LOCATION: Travis Street at Oliver Street, southwest corner**DATE FILED:** January 8, 2025**ZONING:** PD 193 (MF-2)**PD LINK:** <https://dallascityhall.com/departments/city-attorney/Articles/PDF/Article%20193.pdf>**CITY COUNCIL DISTRICT:** 14**SIZE OF REQUEST:** 0.4890-acres**APPLICANT/OWNER:** Mike Giambone, Giambone Design District Projects, LLC**REQUEST:** application to replat a 0.4890-acre tract of land containing all of Lots 22 through 24 in City Block 2/1529 to create one lot on property located on Travis Street at Oliver Street, southwest corner.**SUBDIVISION HISTORY:**

STAFF RECOMMENDATION: The request complies with the requirements of the PD193 (MF-2); therefore, staff recommends approval of the request subject to compliance with the following conditions:**General Conditions:**

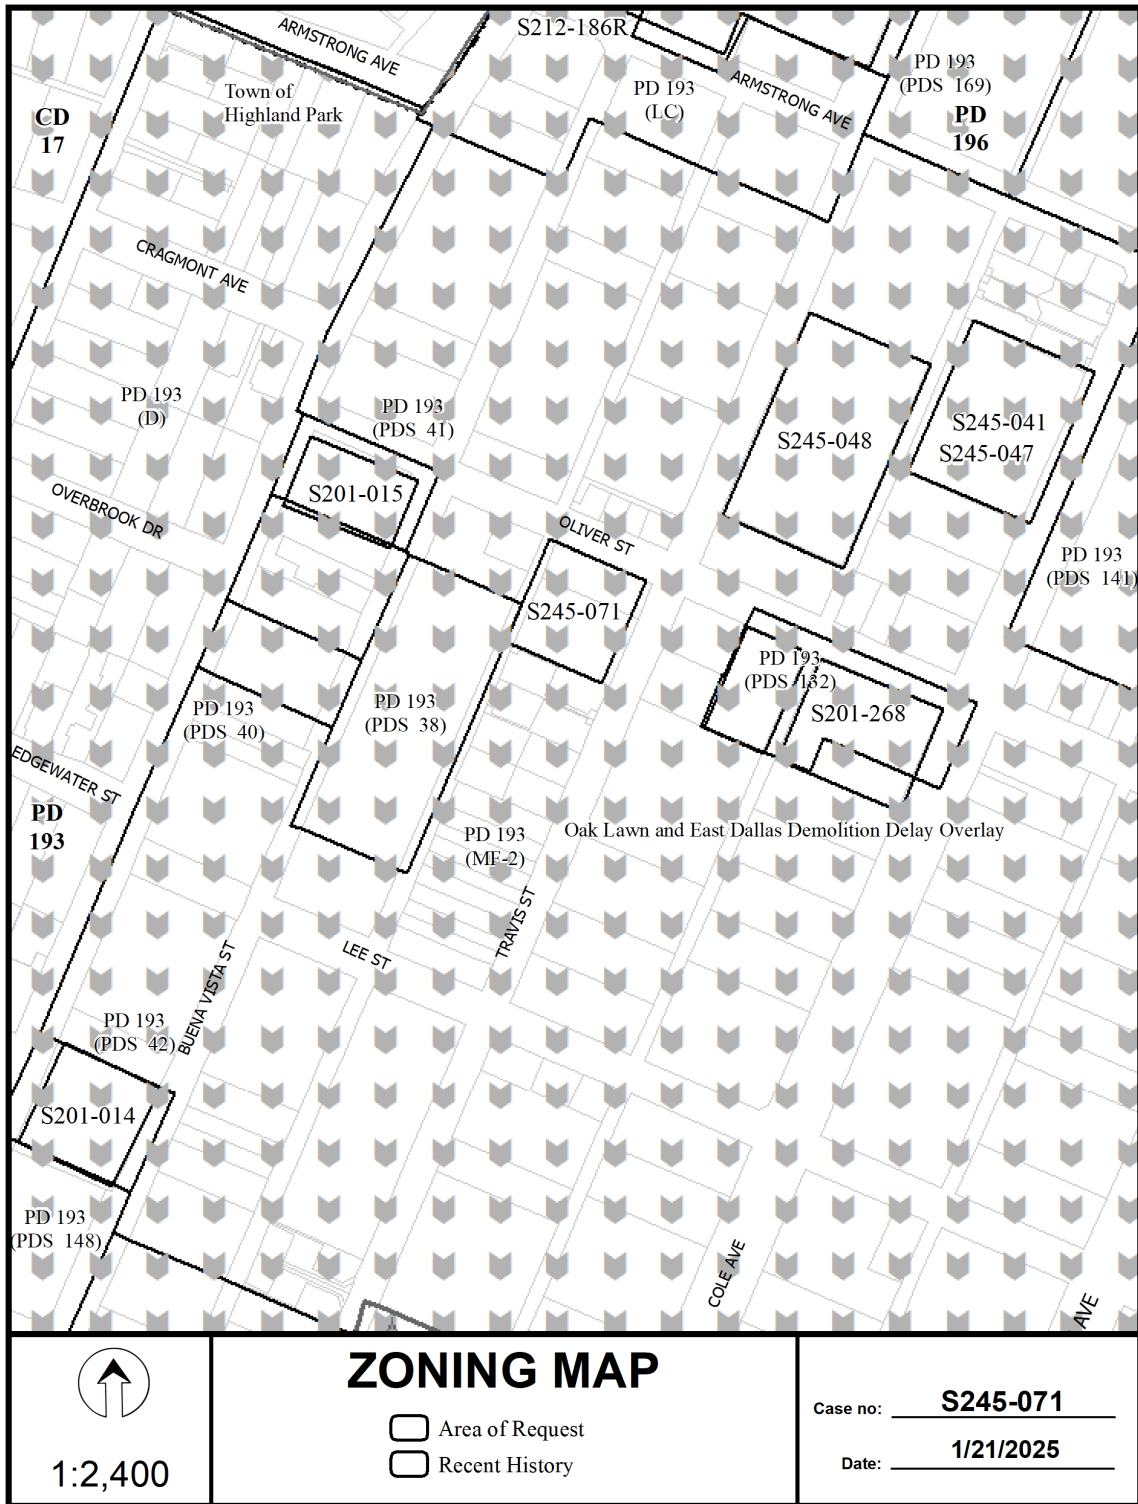
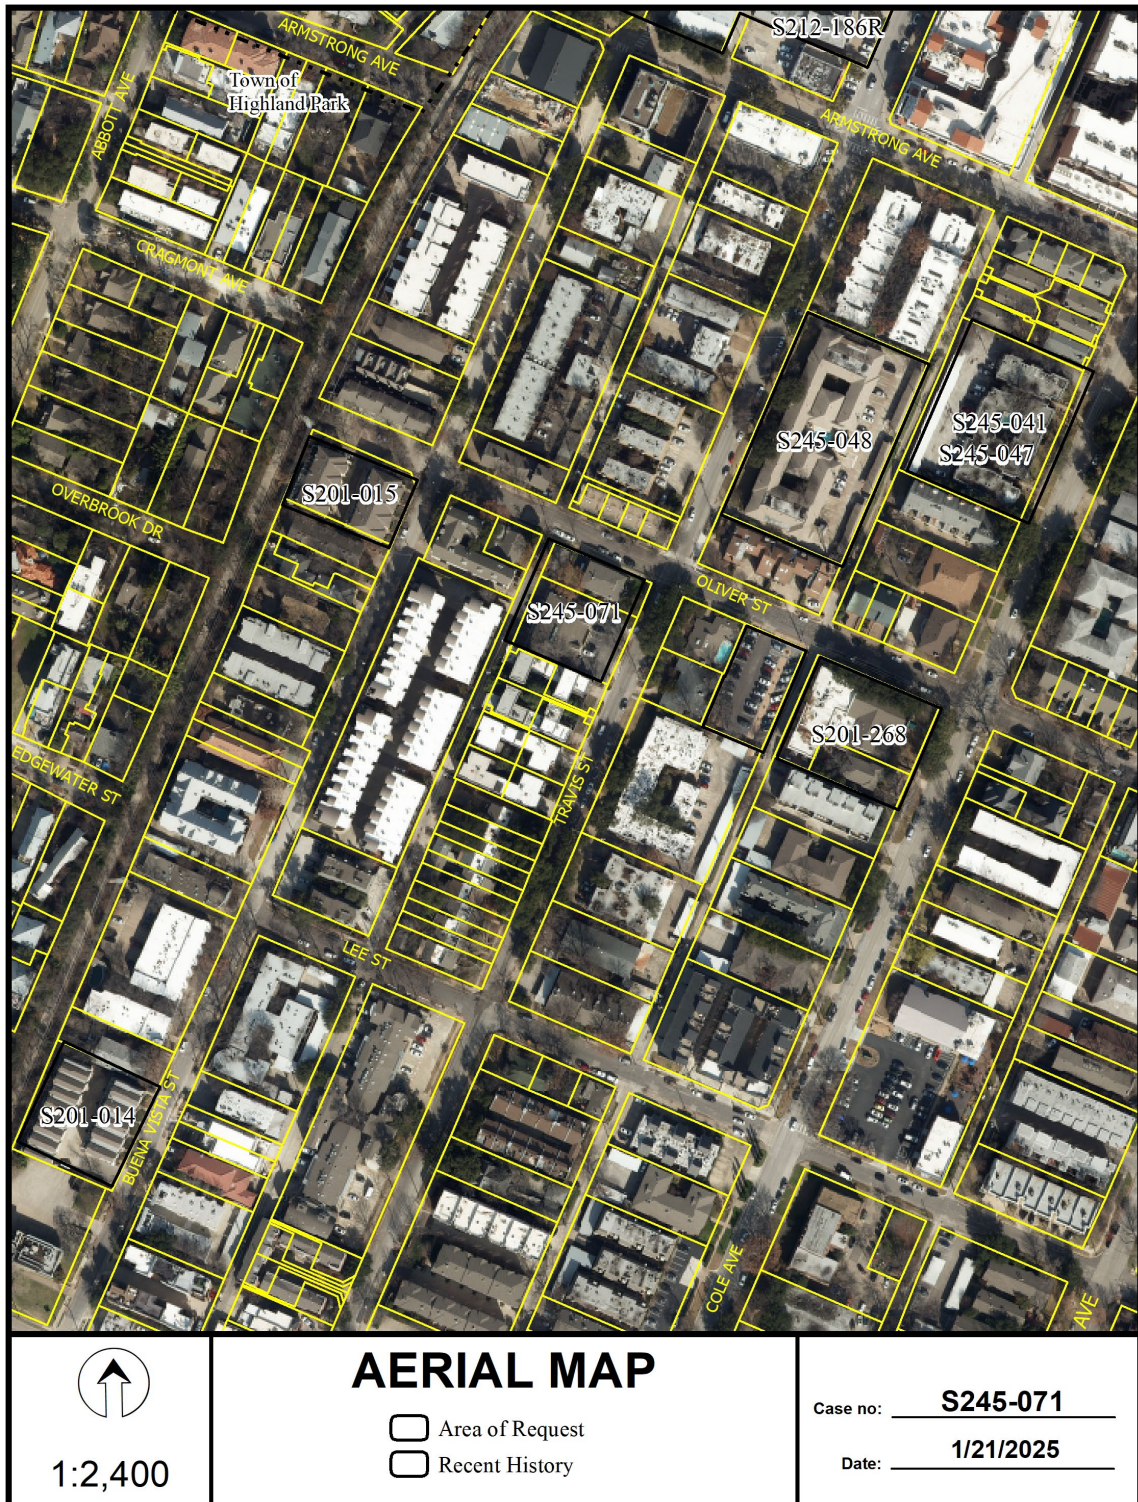
15. On the final plat, dedicate 7.5 feet of right-of-way (via fee simple) from the established center line of Alley. *Section 51A 8.602(c)*

16. On the final plat, dedicate a minimum 5-foot by 5-foot corner clip (via fee simple or street easement) at the intersection of Travis Street & Oliver Street. Section 51A 8.602(d)(1)
17. A larger corner clip may be requested during engineering plan and traffic review to accommodate an adequate turning radius, or to maintain public/traffic appurtenances, within the area of the corner clip. *Section 51A 8.602(d)(1), 51A 8.608(a)*
18. On the final plat, dedicate a 15-foot by 15-foot Alley Sight Easement at the intersection of Oliver Street & the alley. *Section 51A-8.602(e)*
19. Must coordinate with Transportation Department for any traffic signal requirements that are deemed necessary for improving pedestrian accessibility and safety related to site development (Contact Srinivasa Veeramallu with Traffic Signals). *51A-8.606, 51A-8.608*

20. Prior to final plat, submit a completed final plat checklist and all supporting documents.
21. On the final plat, show recording information on all existing easements within 150 feet of the property.

24. Prior to final plat, compliance with City's street lighting standards including illumination standards, material, installation, and activation per Street Design Manual.
25. On the final plat, change "Travis Street" to "Travis Street (AKA Travis Avenue FKA Preston Avenue". Section 51A-8.403(a)(1)(A)(xii).
26. On the final plat, identify the property as Lot 22A in City Block 2/1529.
